SIB 11 11 23

SAFETY RECALL 23V-863: CHECK AND REPLACE CYLINDER HEAD COVER

This Service Information Bulletin (Revision 2) replaces SI B11 11 23 **dated December 2023**.

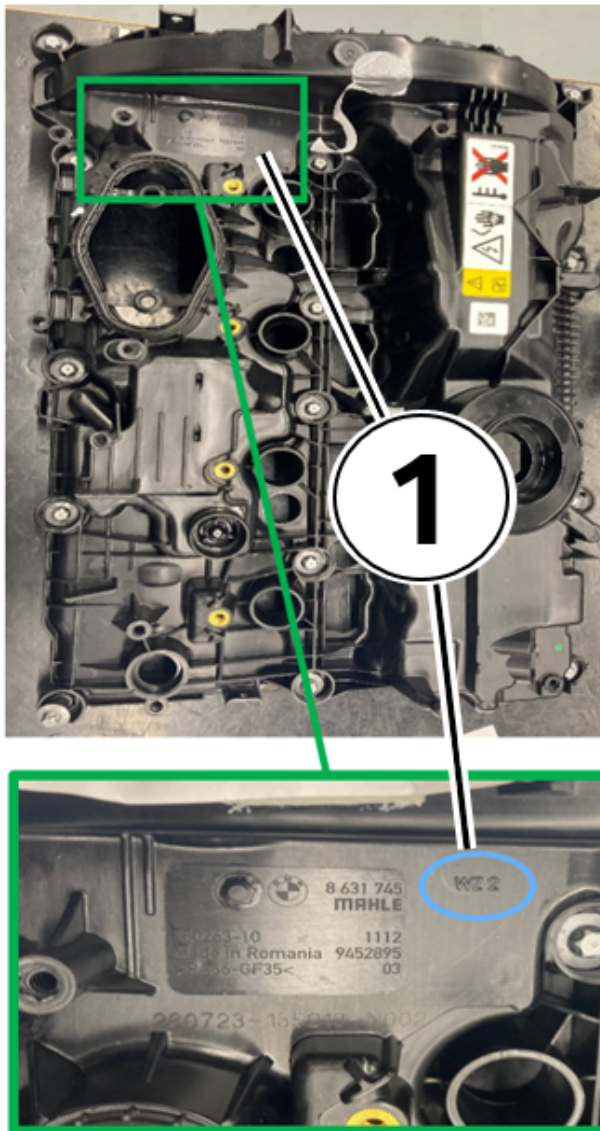
1. Check the cylinder head cover for “WZ2” or “WZ3” embossed in the plastic surface (1).

2. If “WZ3” is on the cylinder head cover, then it does not require replacement.

If “WZ2” is on the cylinder head cover, then it must be replaced.

3. Refer to Repair Instruction 11 12 001 Replacing the cylinder head cover.

Note: The above embossed reference number information only applies to the original cylinder head cover that was installed on the engine at the factory.

Note: The new replacement cylinder head covers received from your RDC are not affected by this recall and can be installed without an inspection. Covers from the RDC may have the WZ2 code but have been verified as being OK to install.
